Subject: AP1000 Response to Request for Additional Information (SRP6.2.2)

A response is provided herein for RAI SRP6.2.2-CIB1-31.

RAI Response Number: RAI-SRP6.2.2-CIB1-31  
Revision: 0

**Figure 2 – Refueling Cavity Drain Line Check Valve, Swing Disc Type**

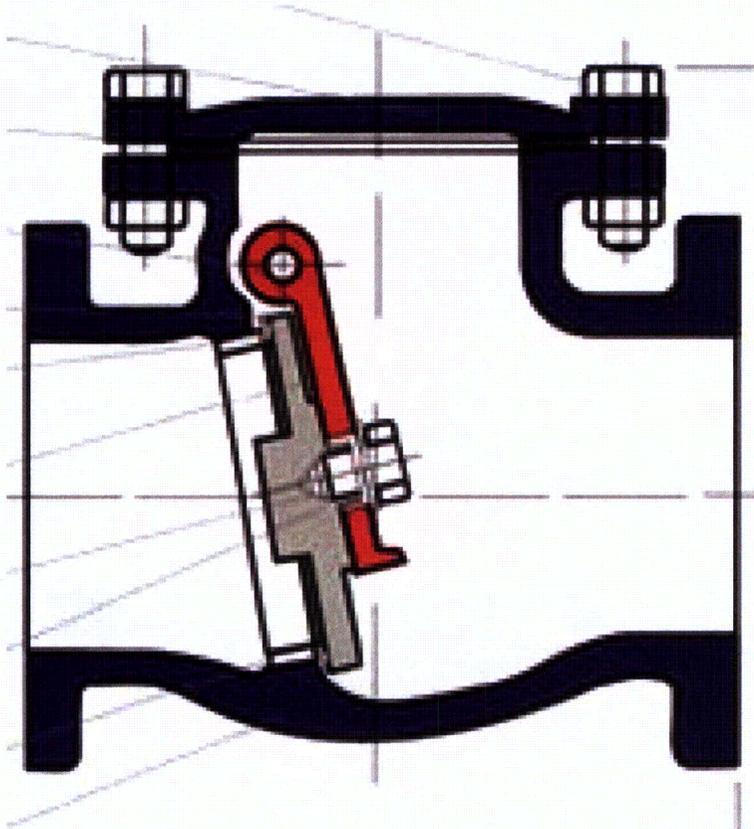
Finally, even if some MRI fines were transported into the drain lines the flow passage through the type of check valve used in this line (swing disc check valve) is not conducive for trapping debris and it is expected that MRI fines as well as latent debris would get carried through. Figure 2 shows a typical swing disc check valve. This line uses 6 inch check valves that are designed to have an low leak rate, [ ]<sup>a,c</sup> each of these check valves is tested in the factory prior to their installation in the plant to verify that their leak rate less than or equal to this value. Although the leakage through these check valves may not be this low in the plant, they will certainly be less than the [ ]<sup>a,c</sup> gpm discussed below. This line has two series valves which contribute to the low probability of significant leakage. These valves currently have inservice testing requirements that stroke each valve open and closed every refueling outage. During this IST, the operation of the check valves is monitored using non-intrusive sensors that verify that the valves operate normally (the disc moves freely, opens and returns to the full closed position). Because of the large margin between the design leak rate and the allowable leak rate these check valves are not subjected to inservice leak rate testing.
